# McLaren Artura – Starter Motor Cable Inspection and Rework

<b>Bulletin type:</b>	Service Information
<b>Reference number:</b>	AFT.006.2024
<b>Campaign reference:</b>	N/A
<b>Attention:</b>	Retailer Aftersales Managers, Retailer Service Managers, Retailer Service Advisors, Retailer Technicians, Retailer Parts Managers
<b>Affected vehicles:</b>	McLaren Artura
<b>Situation:</b>	Confirmation of the 12V starter motor cable correct routing and retention
<b>Procedure:</b>	Confirm correct routing and retention through visual inspection whenever the engine floor is removed
<b>Date:</b>	18 <sup>th</sup> January 2024

This Bulletin supersedes **URGENT Bulletin - AFT.038.2023 - McLaren Artura - Starter Motor Cable Routing and Rework** which has been withdrawn from the Retailer Portal.

**Image 2** Location of fir tree (1)

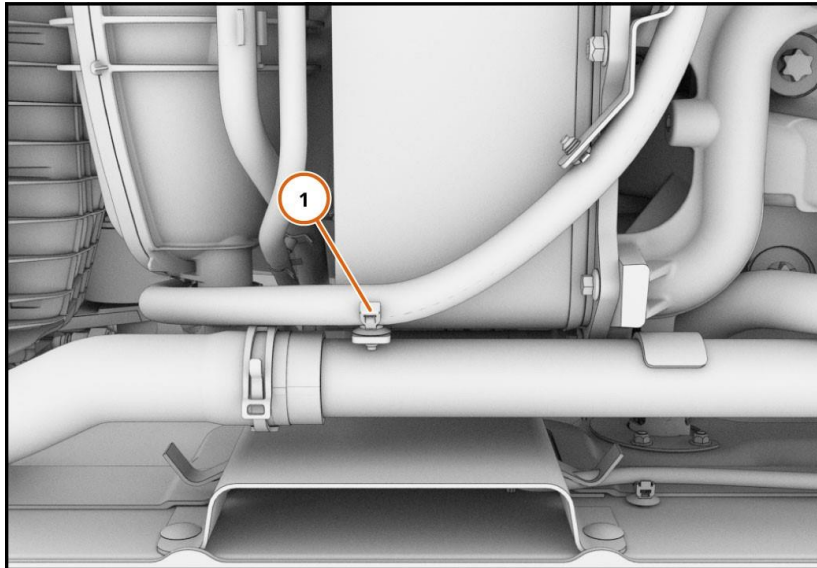
Inspect the fir tree (1). If the fir tree is fully engaged in the anchor point, undamaged and retaining the 12v cable, then no action is required, continue to Step 2.

If the fir tree (1) is damaged and not holding retention, cut it with suitable side cutter pliers and fit a new fir tree 00RL001 in the same position (1).

**Image 3** Location of edge cable tie clip (1)

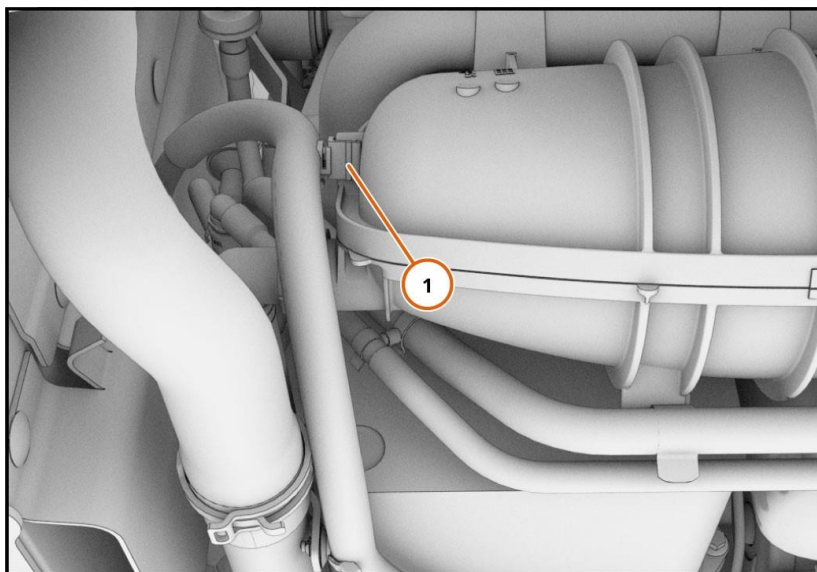
**CARE POINT:** Make sure that the edge clip has sufficient retention to the airbox.  
Take care not to damage the 12v cable and its insulation. Do not use a sharp blade, only side cutter pliers.

Inspect the edge cable tie clip (1) retaining the 12V cable to the air intake manifold shown in the image below. If the edge clip is damaged or not holding retention, cut it with suitable side cutter pliers and fit a new edge cable tie clip OORL022 in the same position (1).

**Image 4** Location of coolant pipe spring clip (1)

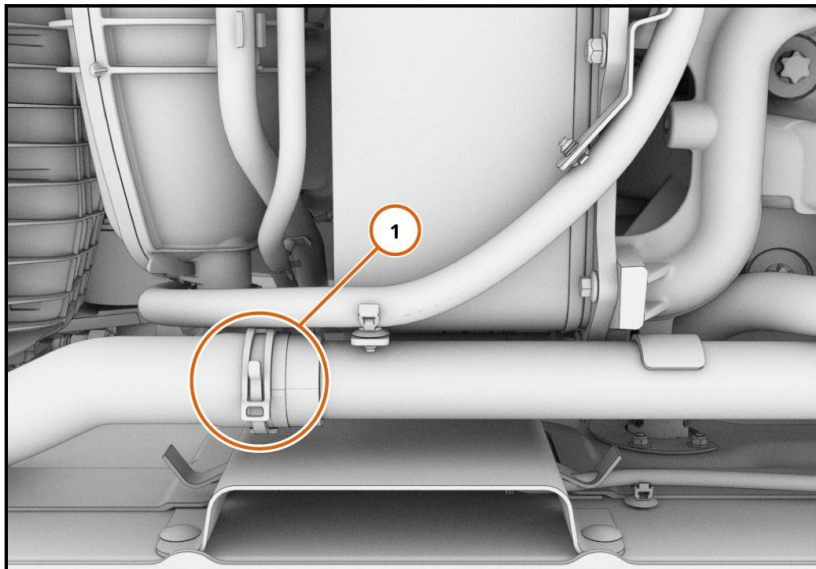
**Care Point:** The coolant pipe spring clip must be orientated with the ears facing downwards.

**Care Point:** Only adjust the coolant pipe spring clip when the powertrain and coolant are at ambient temperature to avoid coolant leaking out of the joint

**Care Point:** Loosen the coolant pipe spring clip just enough to enable it to rotate

**Care Point:** Take care not to create a coolant leak

Make sure that the spring band clip is orientated as shown in the illustration below.

**Image 5** Location and orientation of protective rubber sleeve (1) fitment

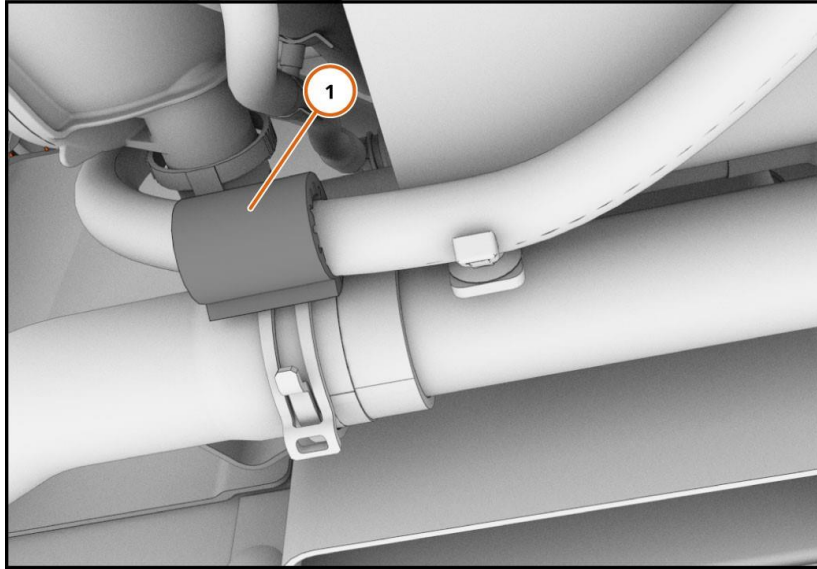
**CARE POINT:** The new protective rubber sleeve is used to create a mechanical clearance gap to the metal spring band clip on the cooling hose and the 12v cable.

Fit the protective rubber sleeve 00RA357 (1) around the 12V starter motor cable in the area shown. The protective rubber sleeve must be fitted in the same orientation as shown and be fully secure.
